IN THE DRAWINGS:

Please cancel the drawings now on file, and please replace by substituting the new set of drawings for FIGS. 1 to 11 attached hereto, as "Replacement Sheets."

Fig. 3b

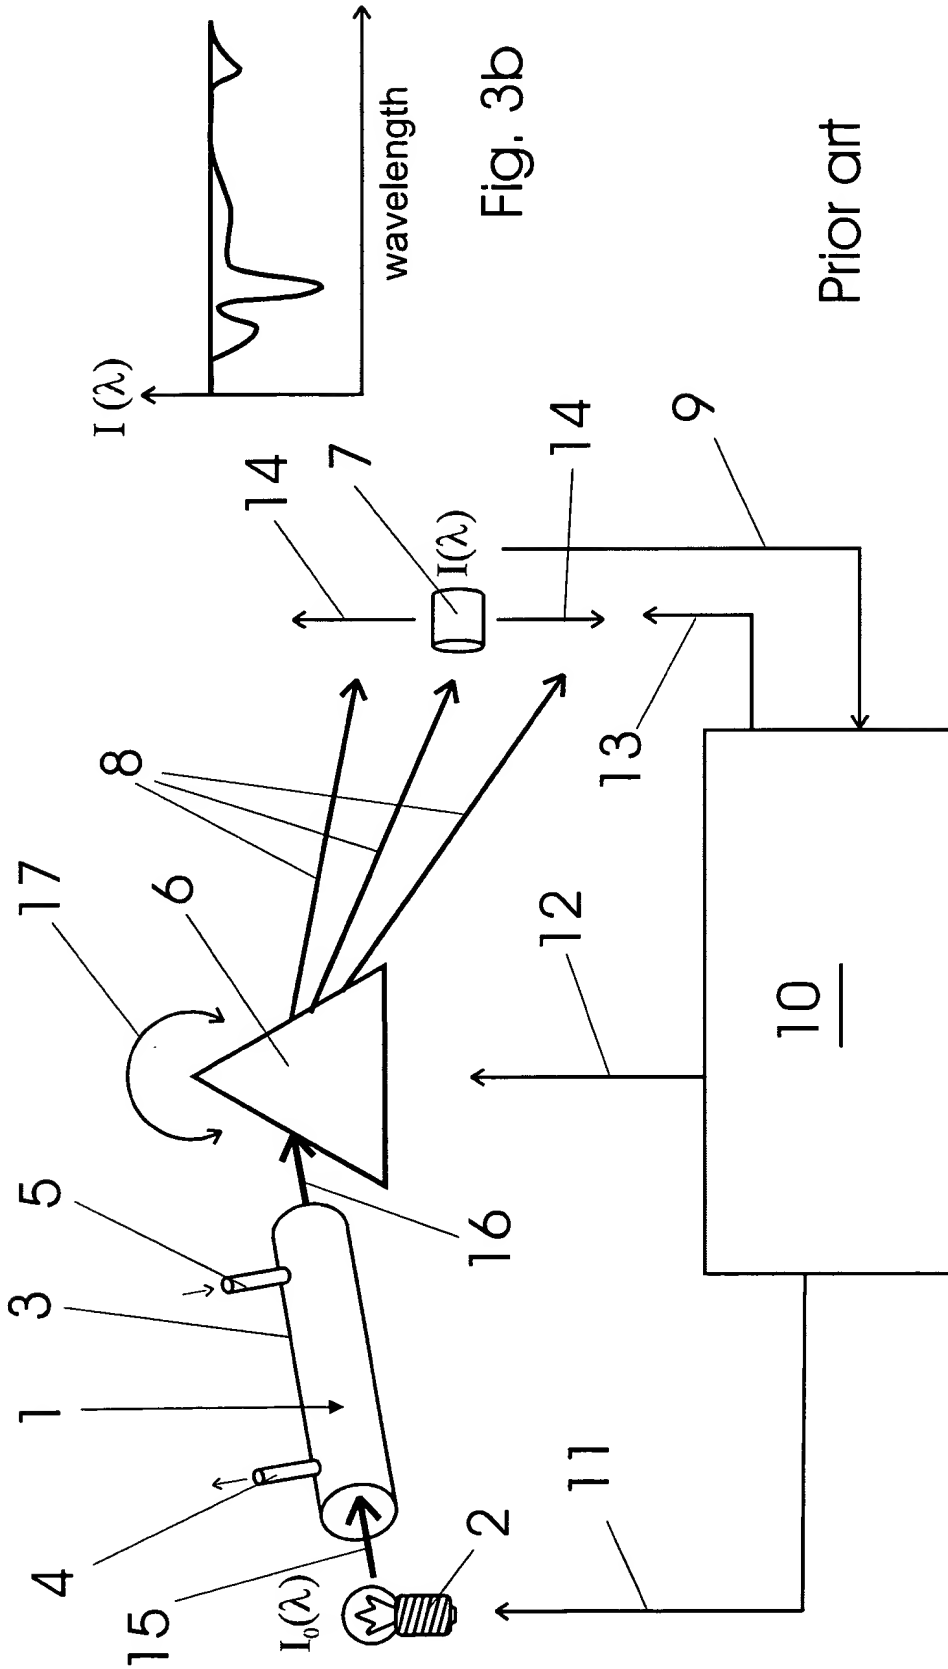
These new drawings have eliminated the foreign word "und." These new drawings have used "Prior Art" instead of "State of the Art" in FIGS. 3a, 3b, 10a and 10b.
